**BCA Assessment Report**

**Goulburn Rehabilitation Unit**

**Sub-Acute Bed Program**

Revision 4

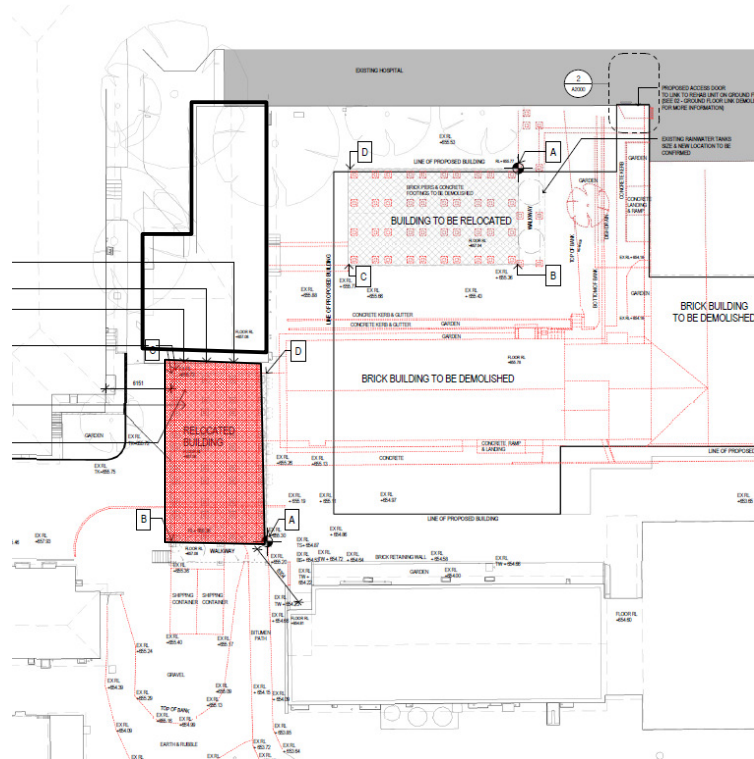
As part of the proposed building works identified above, it is also proposed to relocate an existing lightweight constructed demountable type building to the area shown in the attached site plan:

We note that whilst the demountable building will be positioned greater than 6m from the adjacent buildings to the east and west, the building to the north is located approximately 1m away which poses a risk of fire spread between the two building given that the demountable is of lightweight construction.

In this regard, we would recommend that this non compliance be addressed against the performance requirements of the BCA (prepared by a suitably qualified fire safety engineer), in which case the existing double brick building to the north will have the southern elevation entirely bricked up to achieve a minimum FRL of 120/120/120 to prevent the spread of fire between buildings.

#### **4. Clause C2.5(a)(iv)(B) – Spandrels**

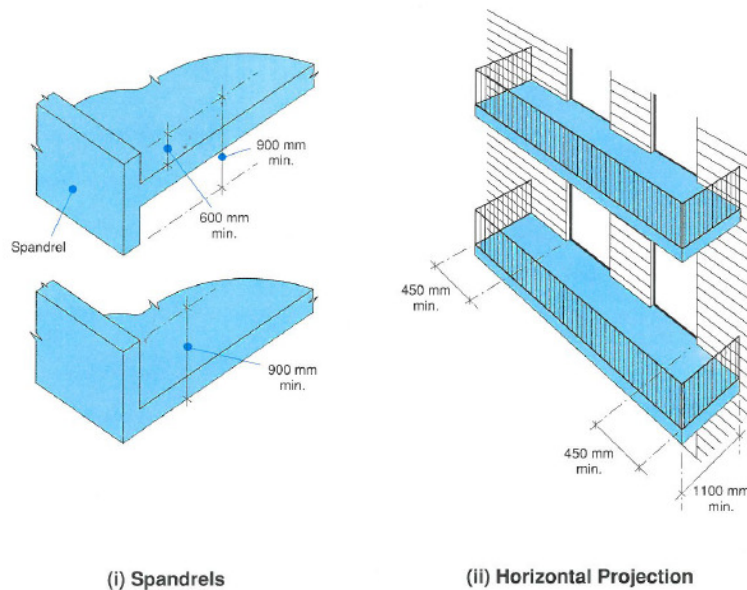
As the building is of type B Construction, the floor separating lower ground and ground floor levels must achieve an FRL of not less than 120/120/120 and the openings in the external wall bounding patient care areas must be vertically separated in accordance with C2.6 of the BCA as indicated in the following diagram:

In this regard we note that spandrel separation has not been provided between the undercroft level and the ground floor plan. Additional details are to be provided in this regard.

## 5. Clause C2.7 - Separation by Fire Walls

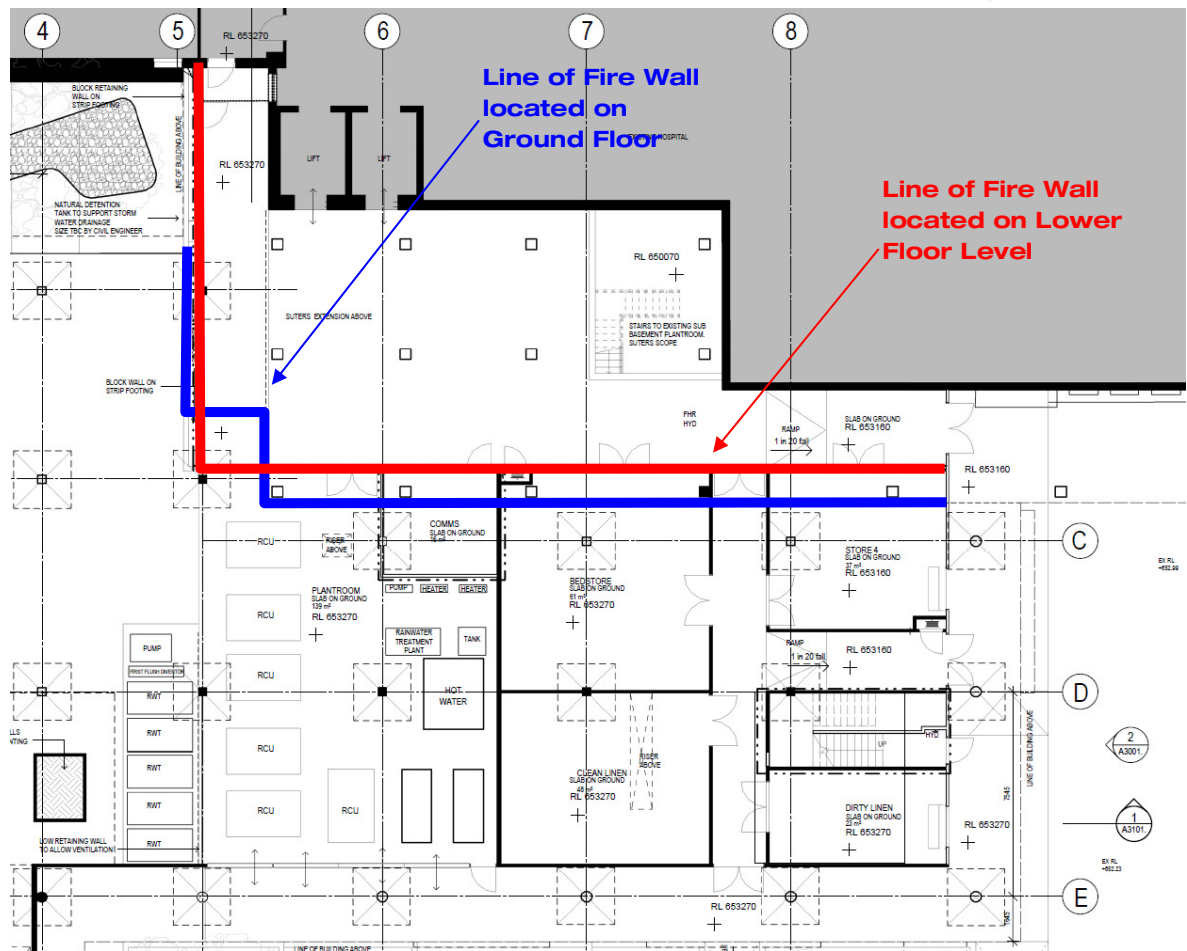
Fire walls (*and fire rated walls*) must extend from the floor slab to the underside of the roof sheeting with no penetrations through the fire wall other than roof battens with a dimension of 75mm x 50mm or sarking.

In this regard we note that the proposed fire wall located between the existing hospital building and Suters extension does not technically comply with the deemed to satisfy provisions of the BCA, in so far as the wall is not continuous between the lower ground floor and ground floor levels as indicated in the below diagram:

Whilst the above is a technical non compliance against the DtS provisions of the BCA due to not being continuous from the floor of the lowest level, this non compliance has been addressed against the performance requirements of the BCA by the Fire Safety Engineer..

## 7. Clause C3.3 -Separation of External Walls and Other Openings in Different Fire Compartments

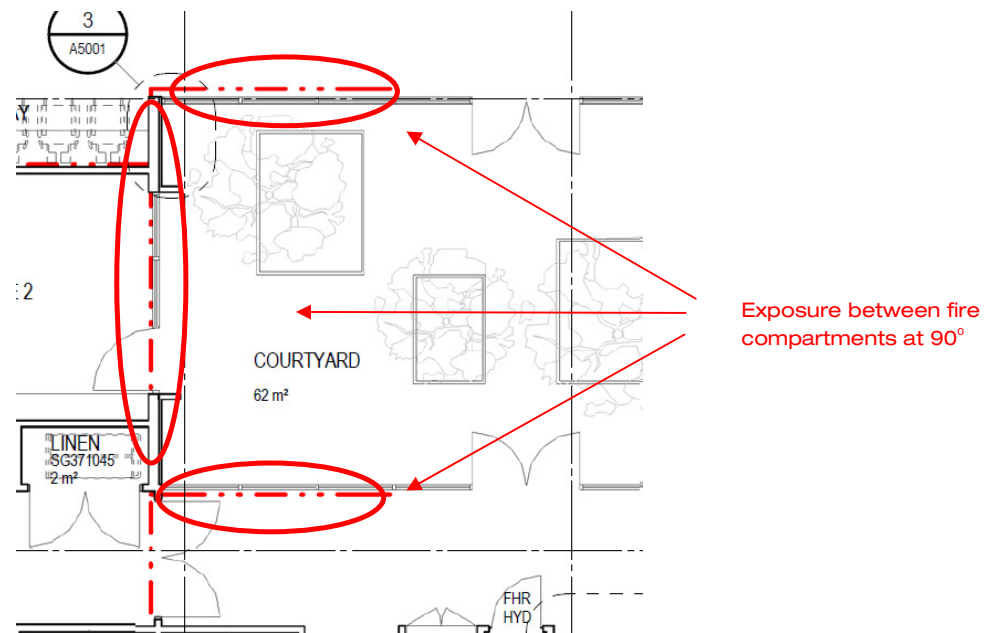
As a result of the proposed new works, we note that there are a number of openings within the external walls of the new RHU and the existing hospital building which are exposed to one another where located in separate fire compartments.

In this instance, should the openings of the new and existing buildings which are located within 4m of another fire compartment not be protected in accordance with Clause C3.4

of the BCA then it will be necessary to obtain a fire engineered alternative solution to justify the non compliances illustrated below:-

In this regard we note that the Fire Safety Engineering report addresses this matter by way of requiring the construction of fire rated walls or installation of drenchers. See Figures 2, 3 & 4 of fire engineering report for further clarification.

### **12. Clause D1.4 – Exit Travel Distances**

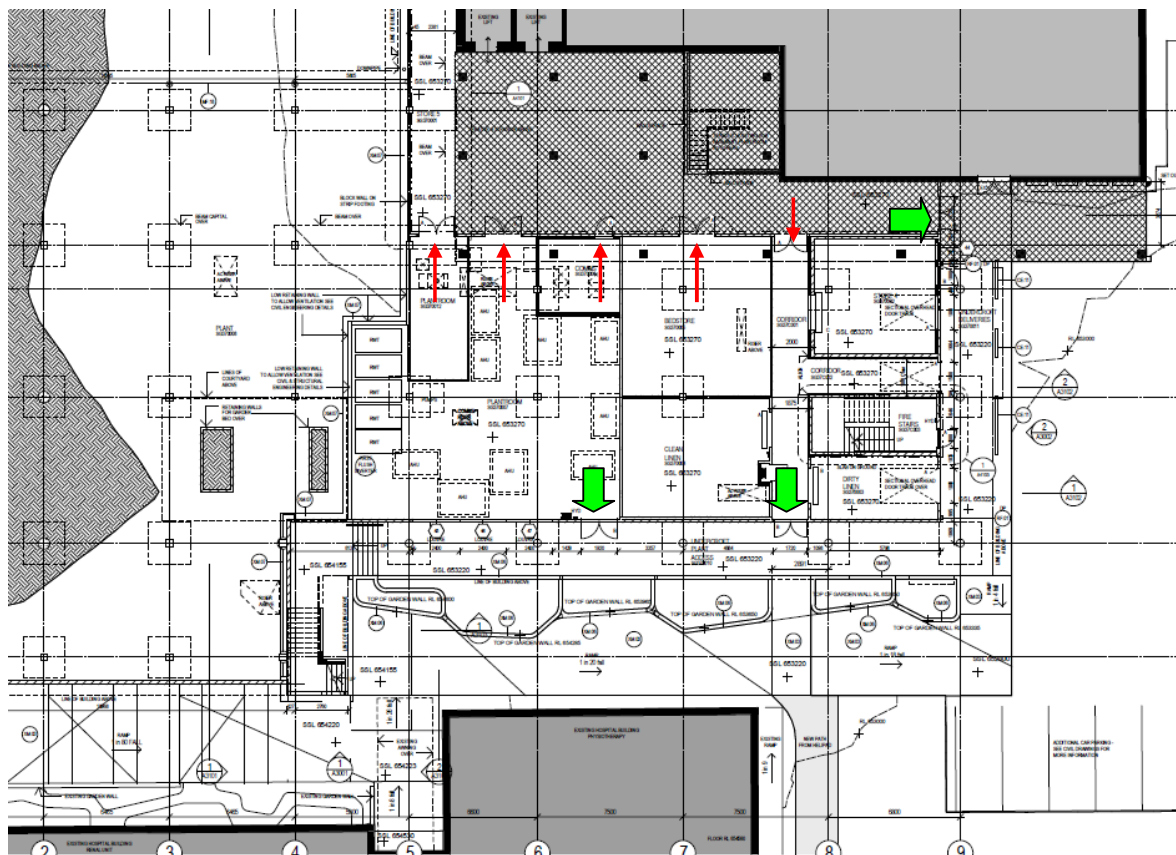
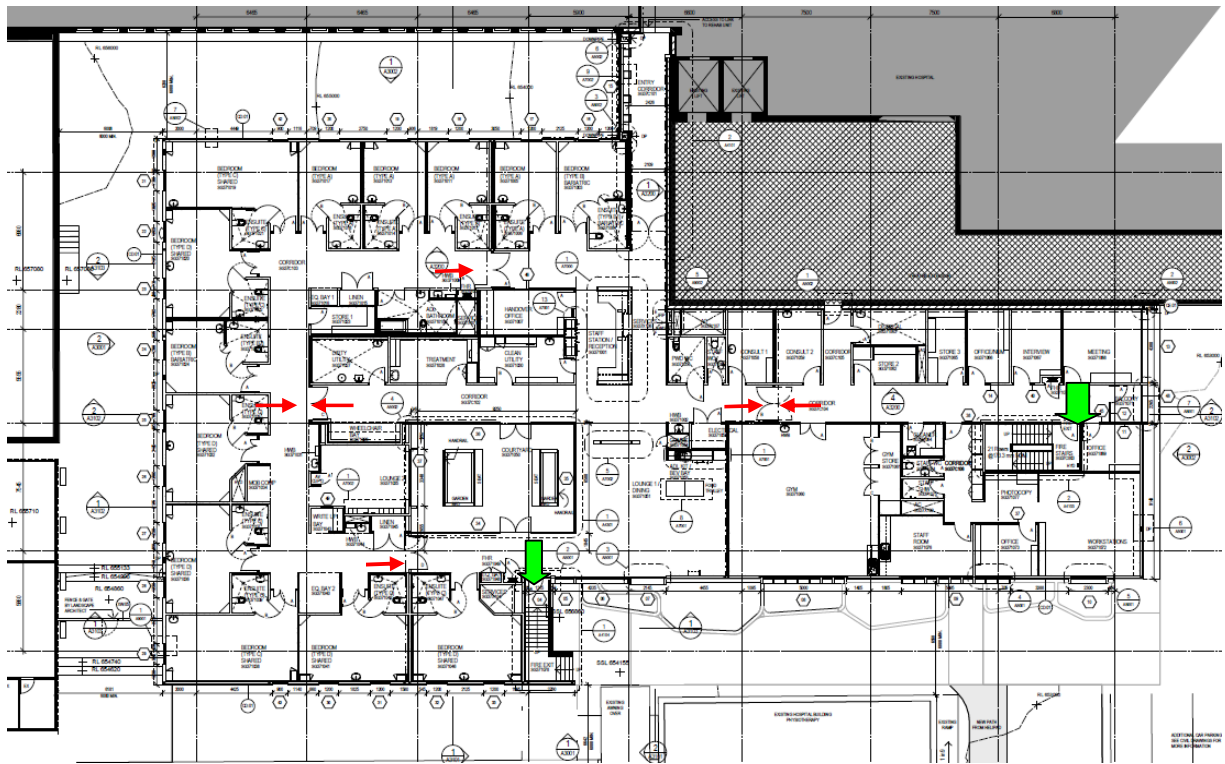
The exit travel distances within the RHU comply with the DTS provisions of the BCA, namely maximum 12m travel to a point of choice and maximum 30m to an alternative exit.

Note: For the purposes of ensuring compliance with the Deemed to satisfy provisions we have considered the fire wall located at the western end of the building to be a horizontal exit to ensure that travel distances comply from this area.

Egress from the central staff station is permitted to have 20m to a point of choice and maximum 40m to the alternative exit. Compliance is achieved in the current design.

The nominated exits from the RHU are illustrated below in green arrows:-

(Note: The required swing of internal fire / smoke egress doors are also indicated below in red arrows)
